A meeting of the Local Traffic Committee will be held at the Council Chambers on November 20, 2024, 11.00am

Subject Get NSW Active Project - Standing Street The

Meeting held 22 May 2024 - 4.2 - Get NSW Active Project - Standing Street The
Channon

Get NSW Active Project - Standing Street, The Channon

Attachment 1: Design Plans

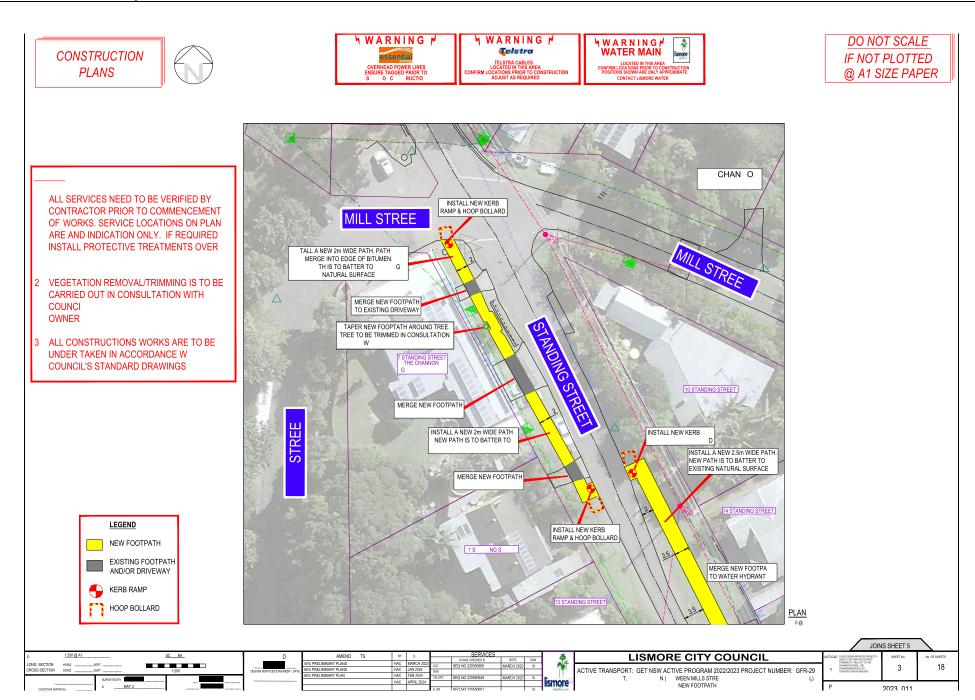
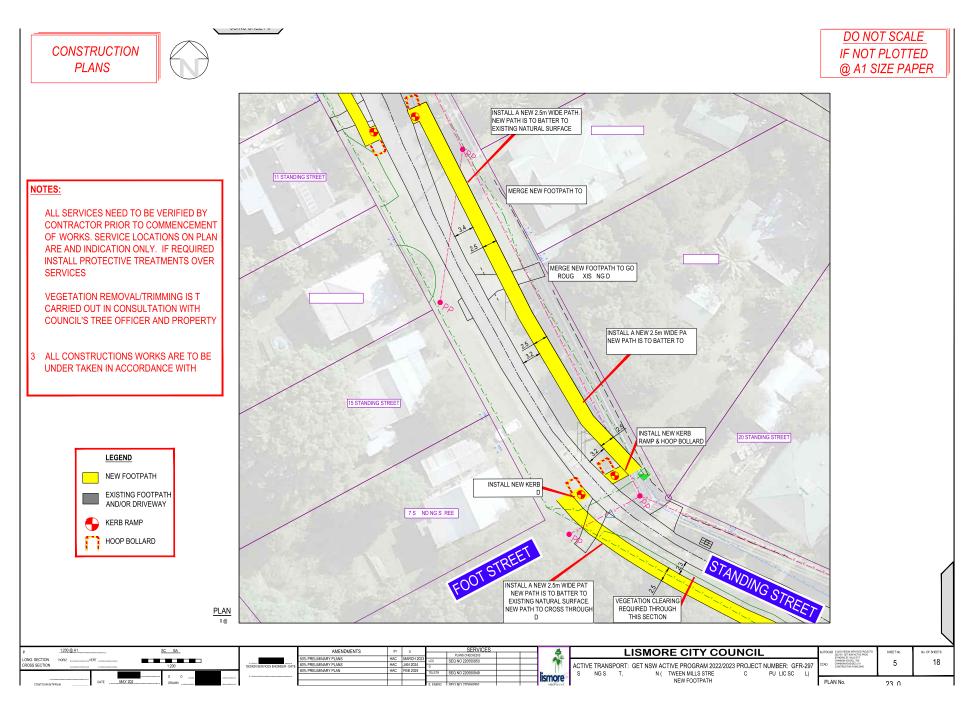
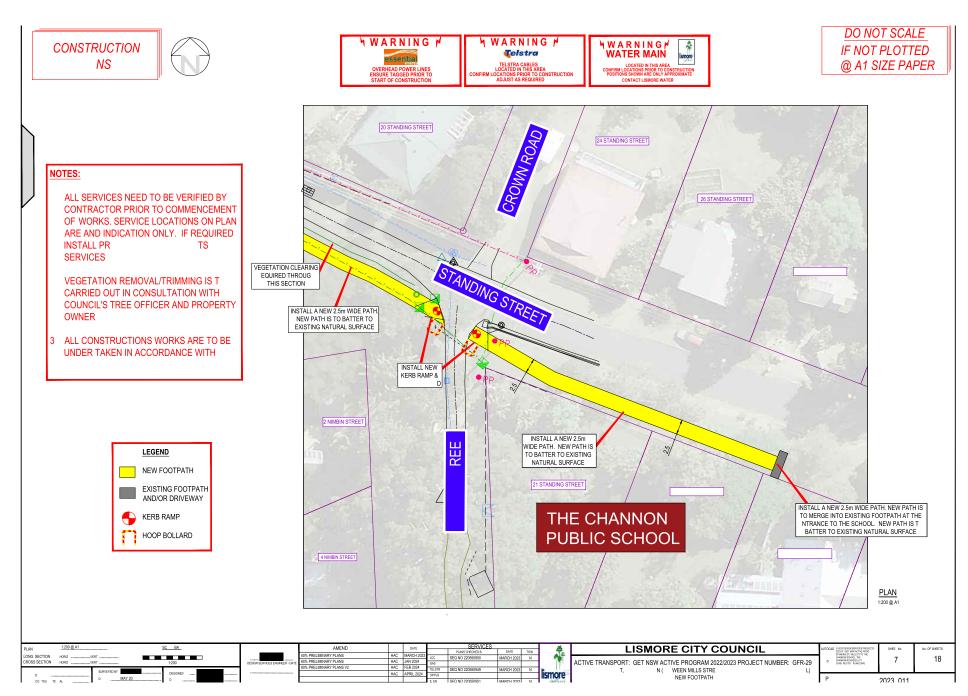
Table 4: Audit Findings					
Item	Dwg No.	Description	Response			
1	3, 5	Multiple Road Crossing The path is shown to cross Standing Street in two locations. Path users must cross Standing Street, then approx. 70m further along the path, cross Standing Street again. This introduces 2 potential points of conflict into the path route. Path users may be struck by a vehicle while crossing the road. Alternatively, path users may choose to walk on the road or verge rather than cross the road. Frequency: Unlikely Severity: Serious Risk: High	Client acceptance Y/N Client response:			
2	3, 5, 7	Hazards Adjacent to Path There are several hazards adjacent to the path: - Small tree near the General Store - Trees on western side of Nimbin Street crossing - Several power poles. Some are adjacent to steeper path grades - Steep bank at School. An errant cyclist could impact one of the hazards. Where the path gradient is steeper, the impact could be at speed. Frequency: Rare Severity: Minor Risk: Negligible	Client acceptance Y/N

3	3, 5	Crossing Driveways	Client acceptance Y/N
		The path crosses several driveways. A vehicle entering or leaving a driveway could strike a pedestrian or a cyclist on the path. A reversing vehicle may run over a child which would be obscured from the driver's line of sight.	Client response:
		Frequency: Rare	
		Severity: Fatal	
		Risk: High	
4	3, 5	Vehicles Parked Across Path	Client acceptance Y/N
		Vehicles currently park in driveways across the proposed path route. These vehicles would be an obstruction and may also cause line of sight issues for passing traffic.	Client response:
		To avoid a parked vehicle, path users may walk or ride on the road, increasing the risk of being struck by a vehicle.	
		Frequency: Rare	
		Severity: Serious	
		Risk: <mark>Medium</mark>	
5	7	Steep Path Gradients	Client acceptance Y/N
		Steeper path down gradients, especially approaching the Nimbin Street crossing, may cause cyclists to overshoot the end of the path into the travel lane.	Client response:

A cyclist may be struck by a passing vehicle or run into a stopped vehicle.	
		Frequency: Rare	
		Severity: Serious	
		Risk: <mark>Medium</mark>	
6	3, 9	End of Path at General Store 1	Client acceptance Y/N
		The path at the General Store has no continuation. There is no signage to indicate that the path ends. Sight distances for path users are restricted.	Client response:
		Path users may cross the intersection in an uncontrolled manner and be struck by a vehicle.	
		Frequency: Rare	
		Severity: Serious	
		Risk: <mark>Medium</mark>

7	3	End of Path at Genera	l Store 2	Client acceptance Y/N
		A hoop bollard is shown across the end of the path. The path has not been widened at the end to accommodate this device.		Client response:
		A cyclist travelling at sp bollard across the path	peed may collide with the hoop n.	
		Frequency:	Rare	
		Severity:	Moderate	
		Risk:	Low	
8	3	Vehicles Parked Adjac	ent to Path	Client acceptance Y/N
		path (particularly near	rk adjacent and parallel to the the Store), there is a risk that a struck by an opening vehicle	Client response:
		Frequency:	Rare	
		Severity:	Moderate	
		Risk:	Low	
9	3	Trip Hazards		Client acceptance Y/N
		northern most drivewa during construction (w	lid/inspection opening in the y to the Store. Unless modified hich is not noted on the plans) hazard to pedestrians.	Client response:
		A pedestrian may trip	and fall.	
		Frequency:	Rare	
		Severity:	Minor	
		Risk:	Negligible	
10	3, 5, 7	Roadside Drainage – V	Vater Flowing Across Path	Client acceptance Y/N

Where the paths cross the road, there does not appear to be any provision for roadside drainage. Water flowing in roadside drains/swales may flow across the path. To avoid the flowing water, path users may walk or ride on the road, increasing the risk of being struck by a vehicle.		Client response:
		Frequency:	Rare	
		Severity:	Serious	
		Risk:	Medium

11	5, 7	Road Width Where Pa	aths Cross Road	Client acceptance Y/N
		and Nimbin Street, ho	shown crossing Standing Street cop bollards are provided. The hoop bollards is too narrow for	Client response:
		bollards or a path user	s may collide with the hoop waiting to cross the road. Or a due to the narrowed road and occur.	
		Frequency:	Rare	
		Severity:	Serious	
		Risk:	<mark>Medium</mark>	
12	5	Angle of Crossing near	r # Standing Street	Client acceptance Y/N
		_	shown near # Standing Street	Client response:
		3	square to the road). Path users ing location, increasing the risk	
		of being struck by a ve		
		Frequency:	Rare	
		Severity:	Serious	
		Risk:	<mark>Medium</mark>	
13	9, 10	Sight Distance to Cros (including from side st	_	Client acceptance Y/N Client response:
		adequate for drivers of	crossing locations may not be or path users. For approaching vance warning of the crossings	
		Path users may be struck by a vehicle while cross the road.
